Pots date to 1962 Speaker dates to 1965 1x15" Tweed style amp in Green tolex		Obsolete Electronics, Inc	
		Guild Model 100-J Guitar Amp, Circa 1965	
March 16, 1996	SCALE	SIZE B	FSCM NO
		DWG NO 1	REV A
		SHEET

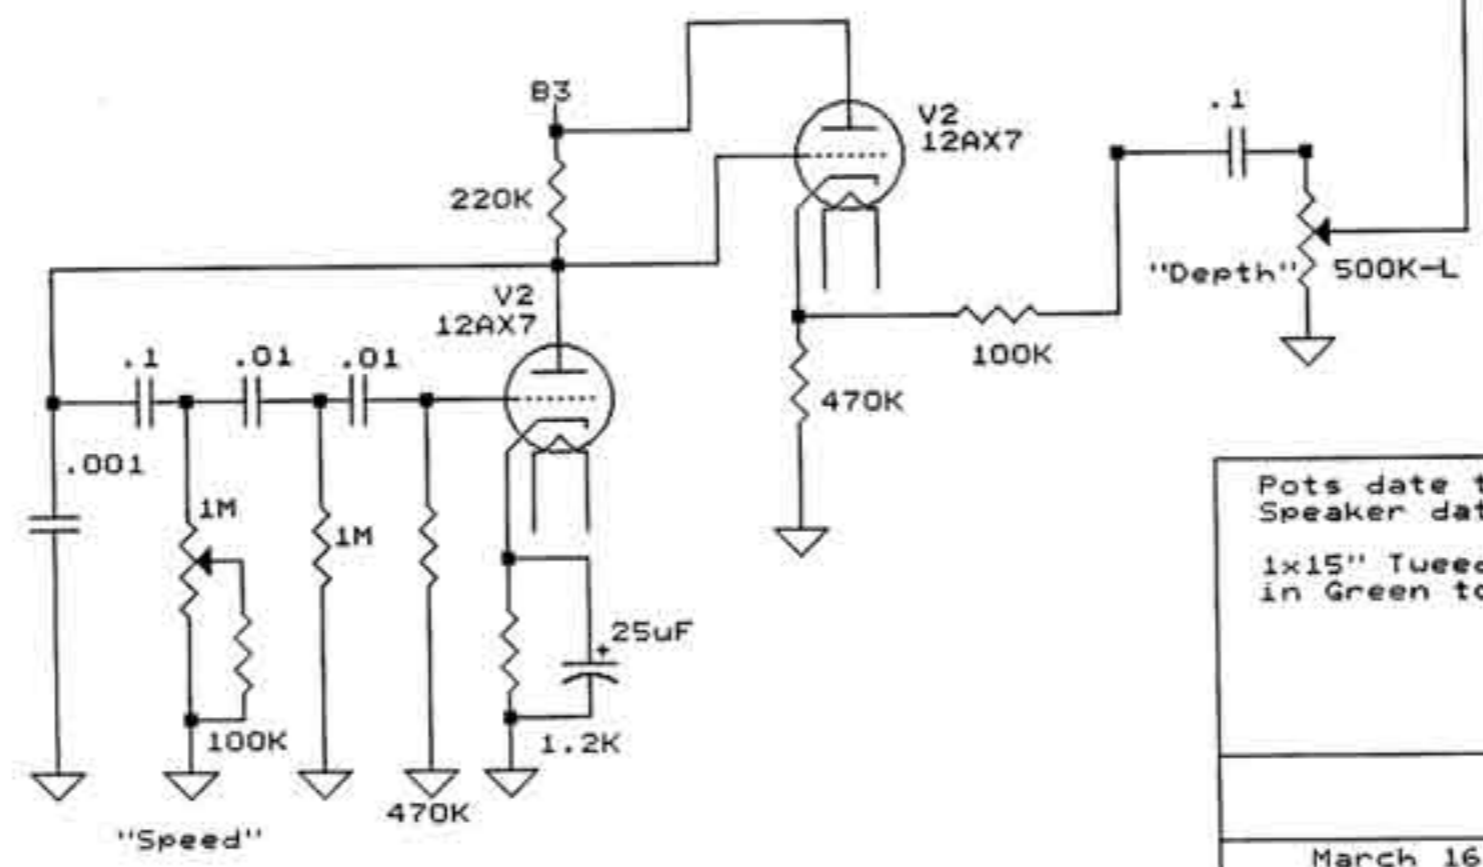
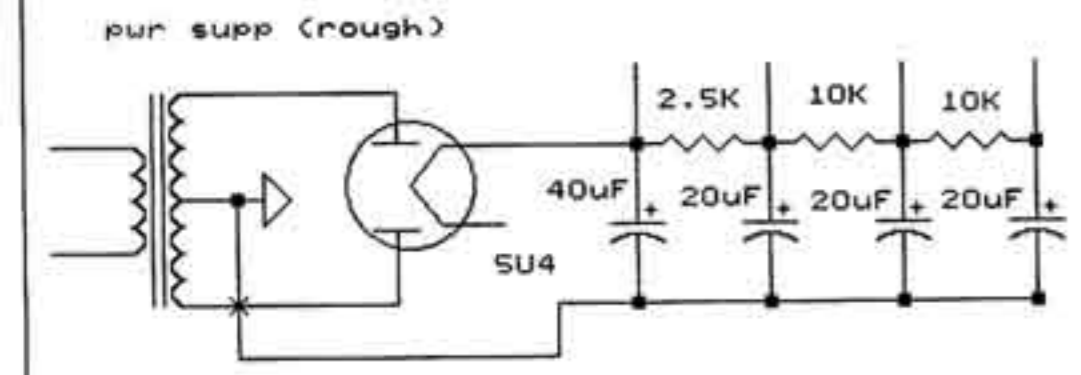
3/96: Placed 33V Zener in CT of PT and dropped B+ by 37V, Idle Dis from 26W to 20W. B+ at plates now roughly 400V. .1uF Cap is for noise suppression.

Note: Original PT replaced, Output Rk changed from 200 Ohms.
